## 5.2 T230127 PA - 30 Bunyip-Modella Road, Bunyip - Development of Land for Two (2) Warehouses and a Reduction in the Number of Car Parking Spaces Required

**Responsible GM:** Lili Rosic  
**Author:** Ana Neiva

That Council resolve to Grant a Permit for Planning Permit Application T230127 PA for *Development of Land for Two (2) Warehouses and a Reduction in the Number of Car Parking Spaces Required* subject to the following conditions:

SWEPT PATH DIAGRAMS ENTRY  
SRV & MRV SWEEP PATHS  
1 : 150

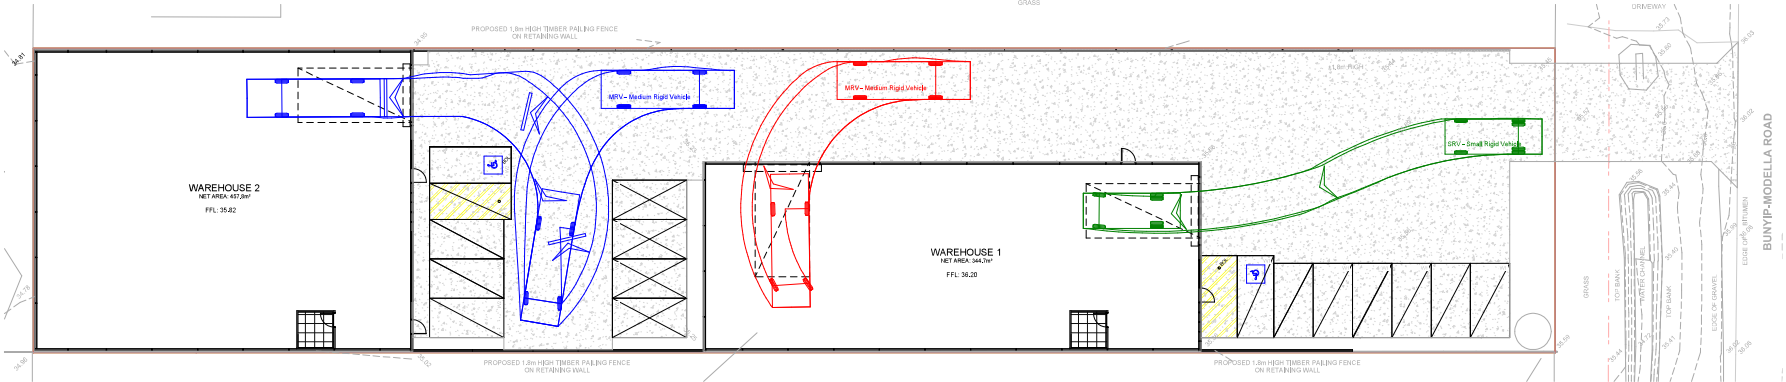
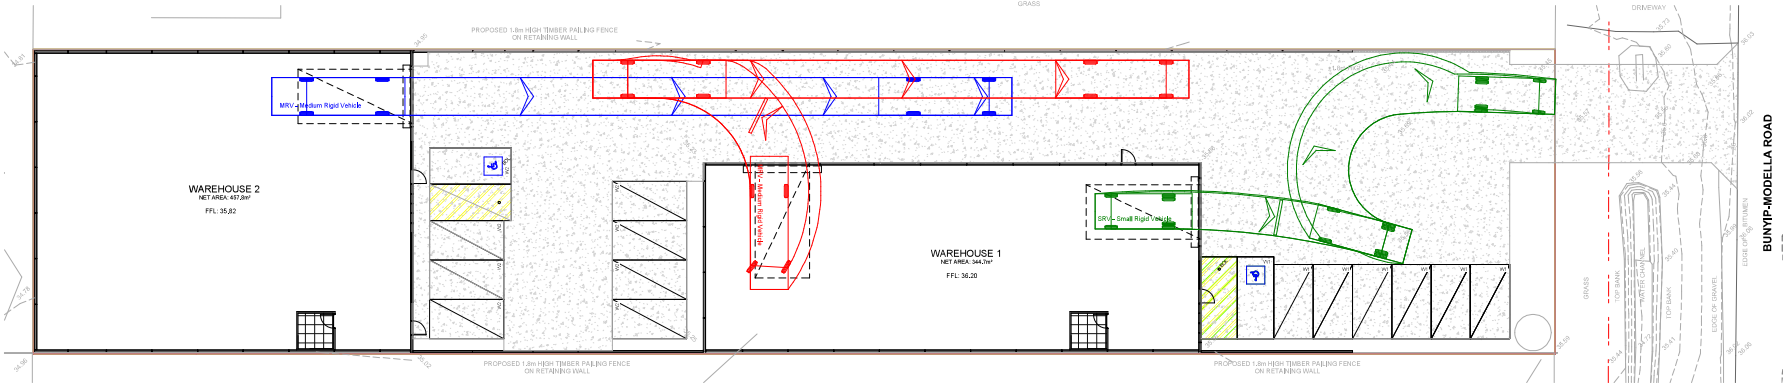
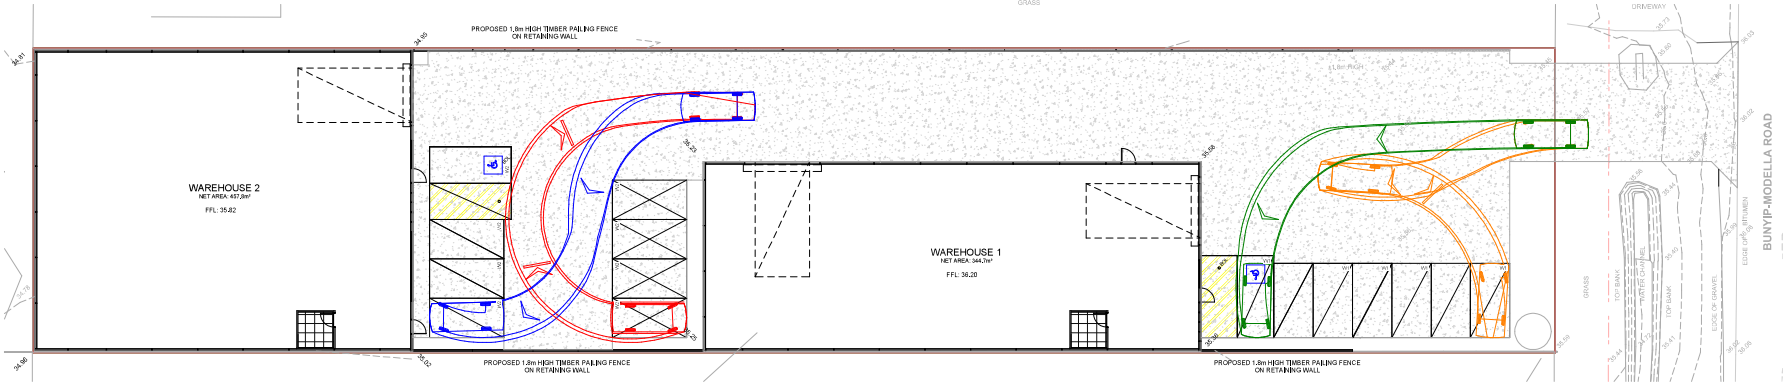
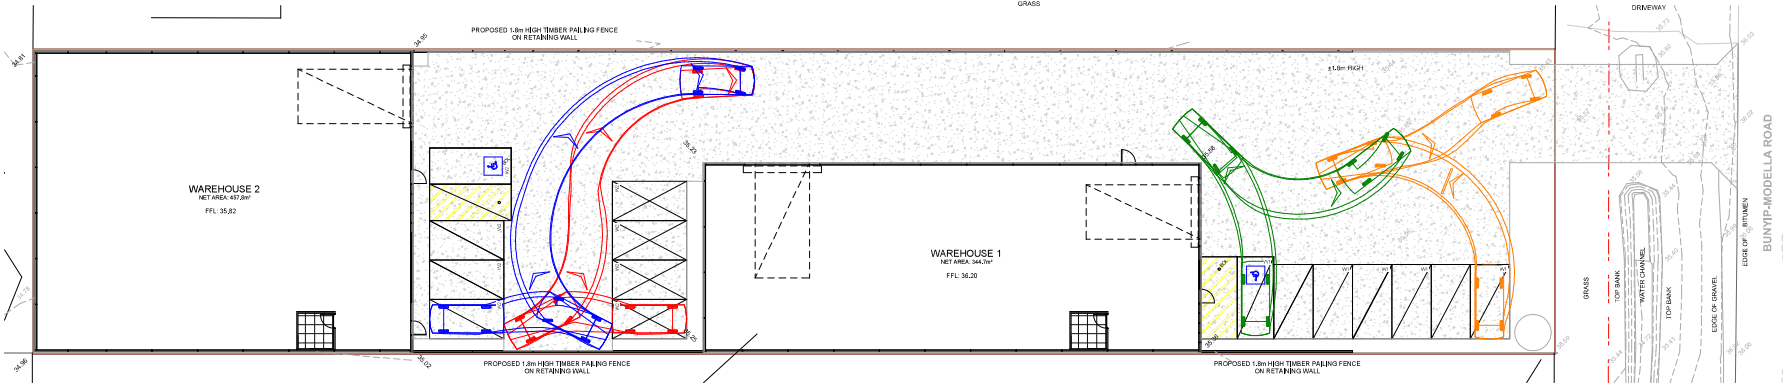
Clause 52.06-9 outlines design standards for car parking. As shown below (Figure 16), all car parking spaces (excluding accessible spaces) are to be 4.9 metres in length and 2.6 metres in width, while the minimum width of proposed internal accessways is 6.4 metres. These spaces are the minimum sizes required by Design standard 2 of Clause 52.06-9, complying with the standard.

10. Vehicular access is restricted to a maximum vehicle length of 8.8 metres (Medium Rigid Vehicle).
11. The areas set aside for car parking shown on the endorsed plans must be made available for use free to employees and visitors at all times, and must not be used for any other purposes.

LANDSCAPE CONCEPT 1:150

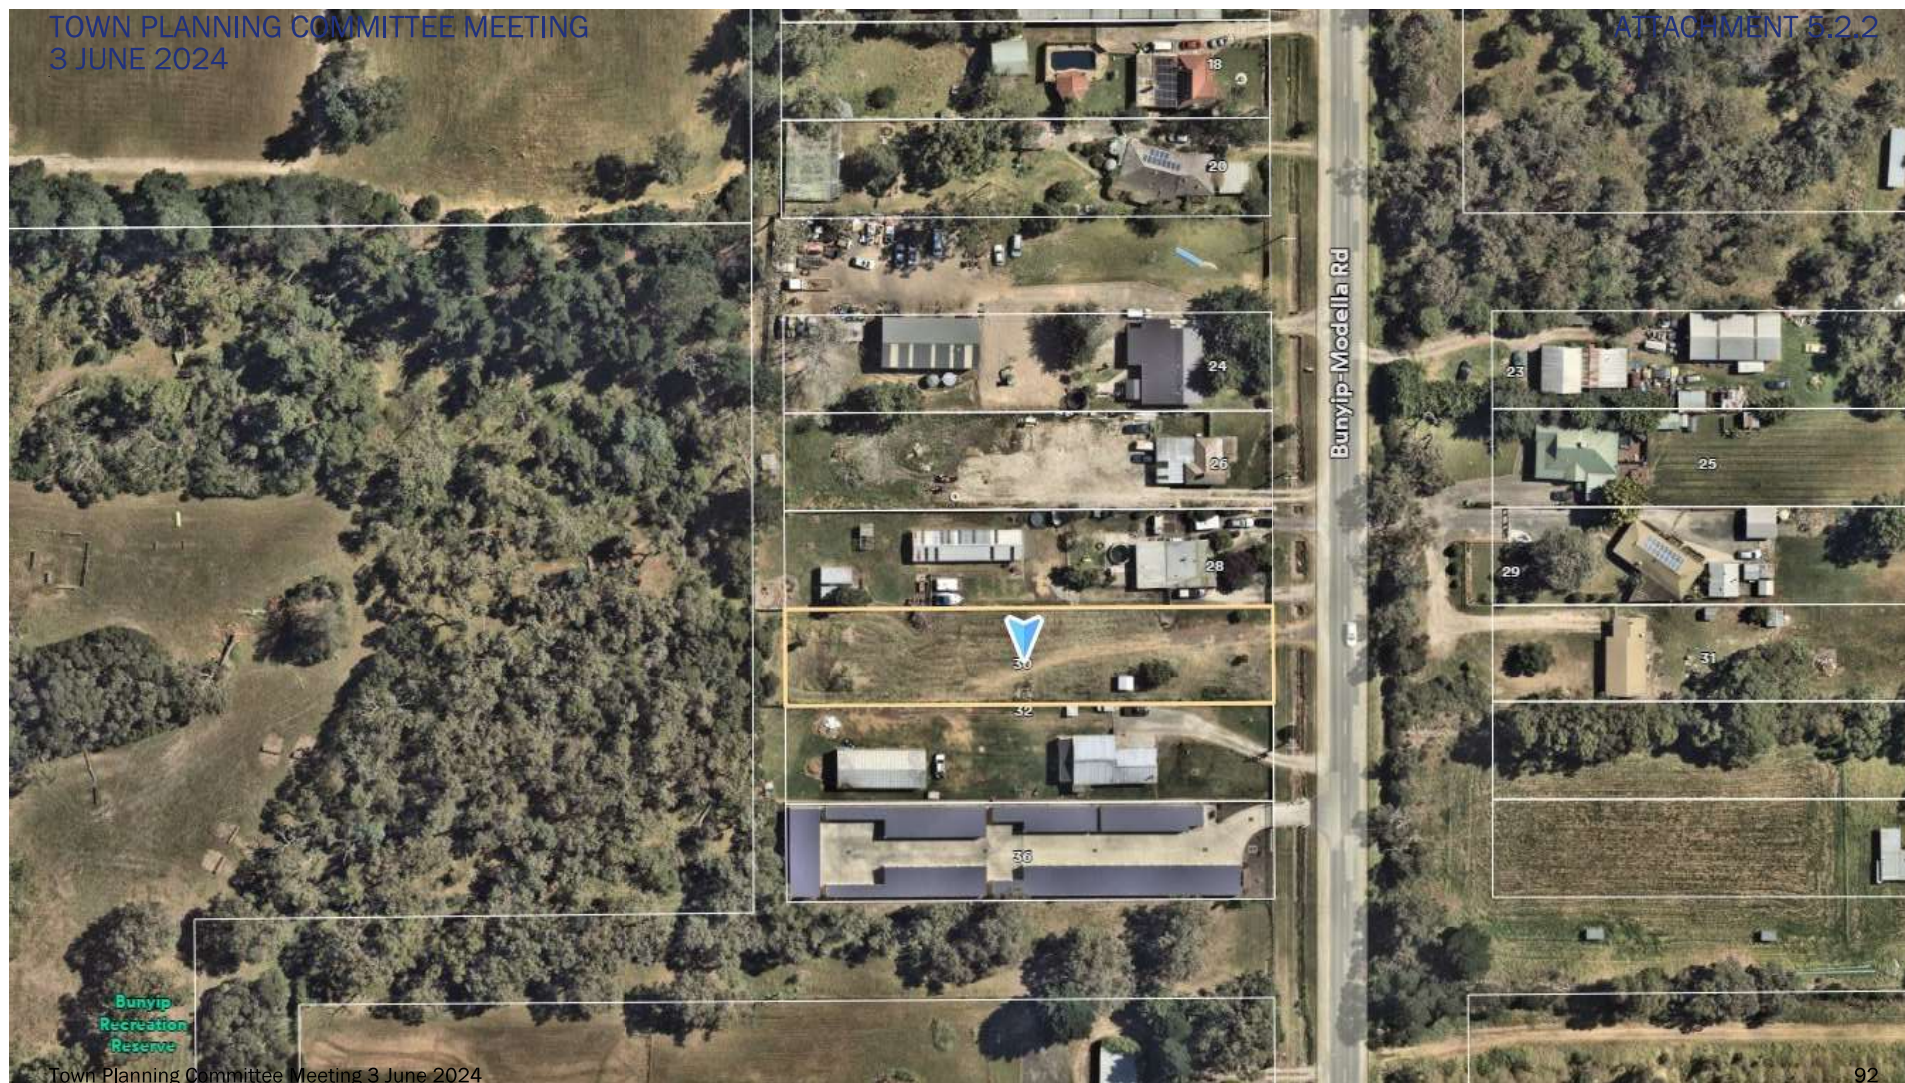
2. Before the development commences an amended landscape plan prepared by a person suitably qualified and experienced in landscape design to the satisfaction of the Responsible Authority must be submitted to and approved by the Responsible Authority. When approved, the plans will be endorsed and will then form part of the permit. The plan must be drawn to scale with dimensions and must be submitted electronically. The plan must be generally in accordance with the plans submitted with the application but modified to show:
  - a. Each individual proposed planting notated to state the species.
  - b. An updated planting schedule to include the total quantity of proposed plantings for each species.

Figure 1: Site Plan

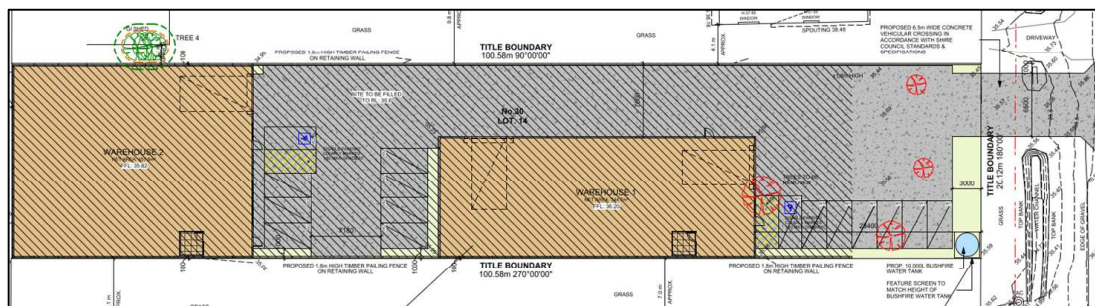
Access to the site is provided via a single 6.5 metre wide crossover, in the north-eastern corner of the lot. A 10,000 litre firefighting water tank is located in the south-eastern corner.

- a. Modifications required to extend the existing crossover to a minimum width of 6.5 metres.
  - b. Driveable end walls incorporated to the satisfaction of the Responsible Authority.

Figure 4: Submitted Landscape Plan

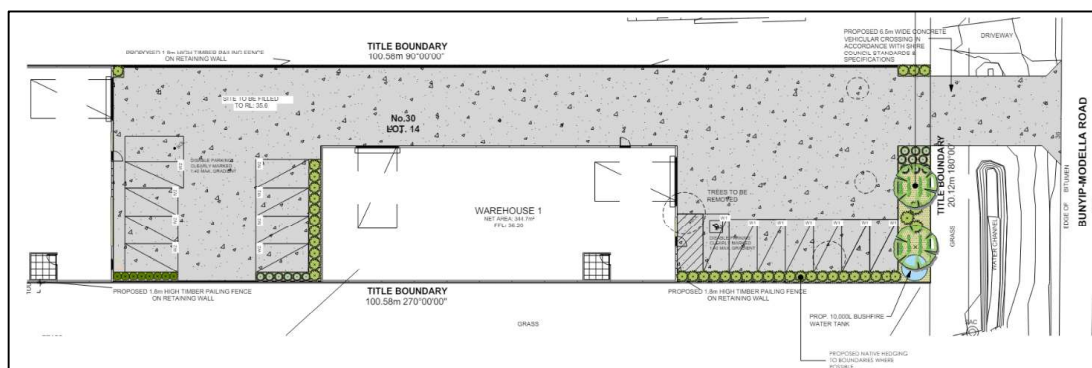
Across the broader site, the majority is to be hardstand concrete areas, dominated by a 7.5 metre wide accessway running the length of the northern (side) title boundary. A three metre wide landscaping area is provided along the site frontage, as well as along portions of the southern boundary and to the west of Warehouse 1. A landscape plan has been submitted with the application, which includes planting across all areas of the subject site. Two canopy trees are proposed to be planted along the front (eastern) title boundary, as well as native hedging along the southern boundary and to the west of Warehouse 1. Two small landscaping areas are proposed along the northern boundary. Specific quantities of plantings are not known, with this to be required by Permit Condition.
